Proposed Pool House  
Woerner  
145 Huntington Dr.  
Dunn, N.C. 28334

Woerner Pool House  
145 Huntington Dr.  
Dunn, N.C. 28334

SP210608  
 145 HUNTING DR.  
 DUNN, NC

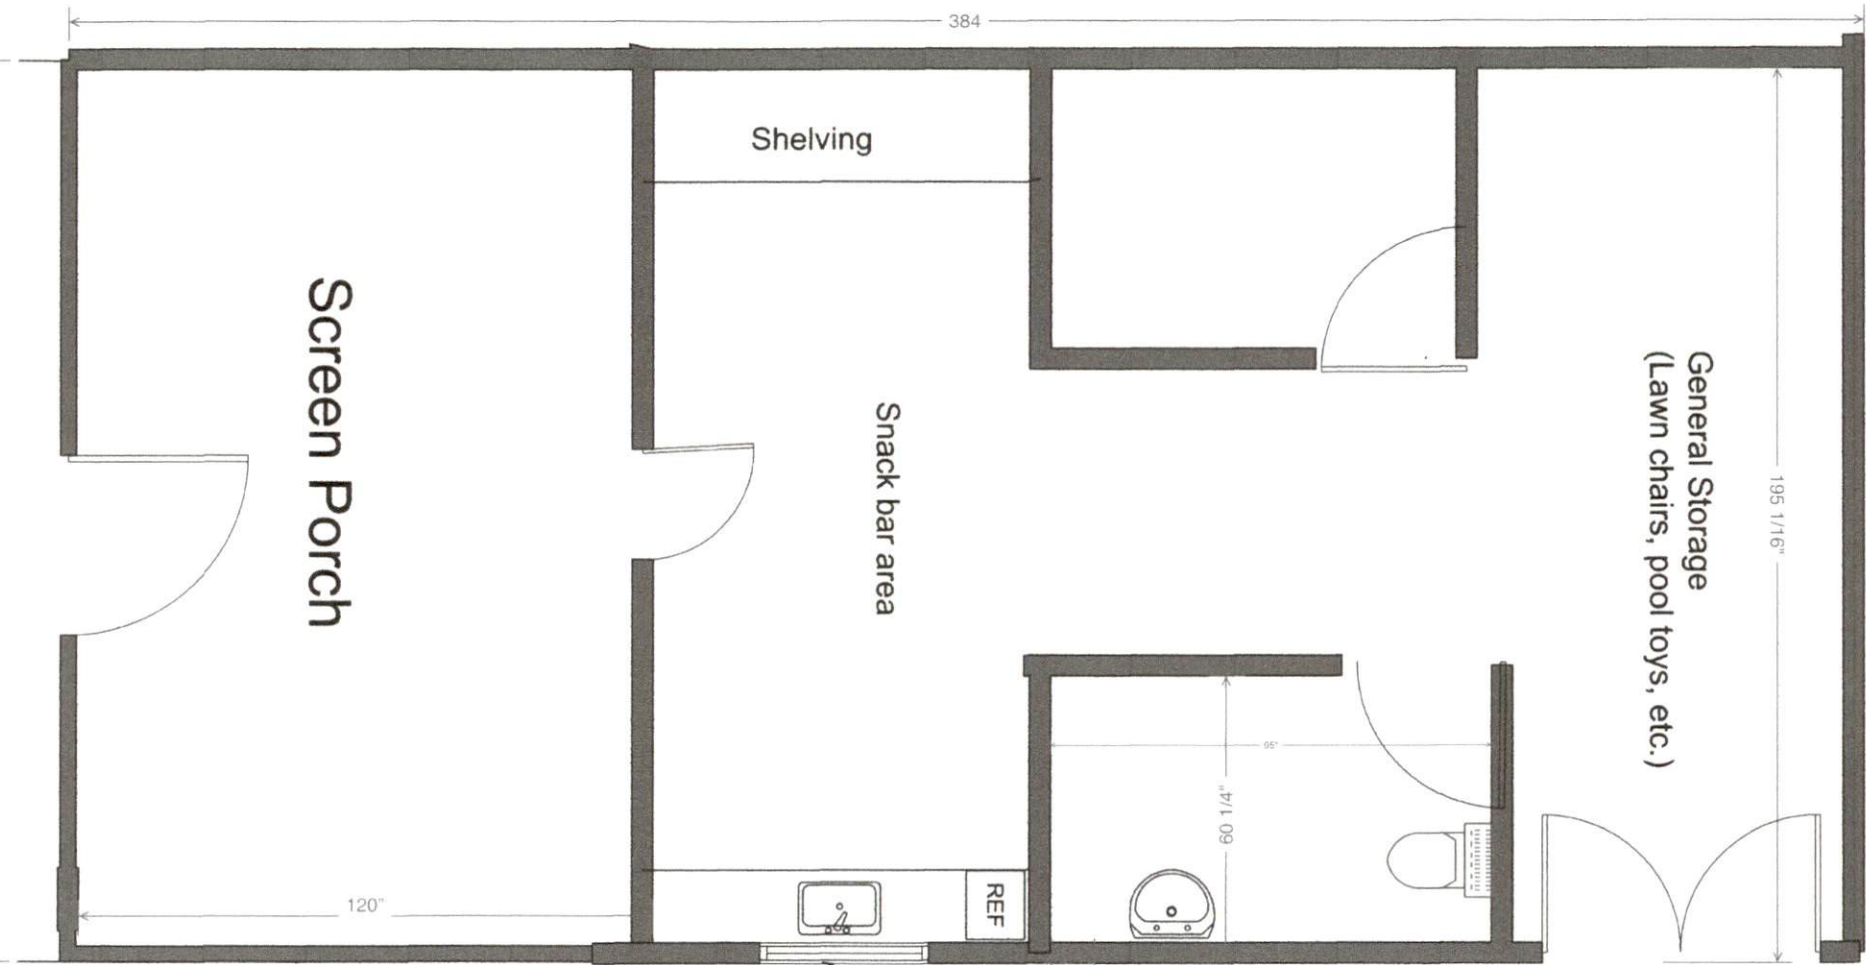
See updated foundation

# New Foundation Dwg

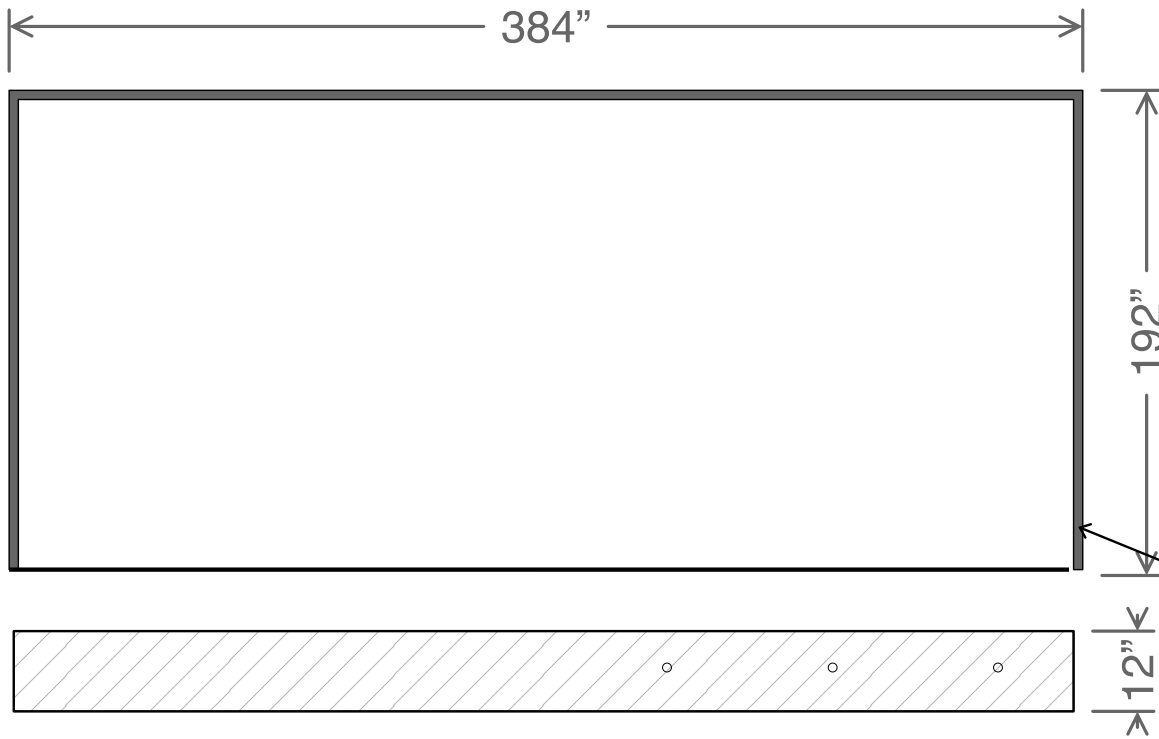
Poured concrete  
 Entire perimeter
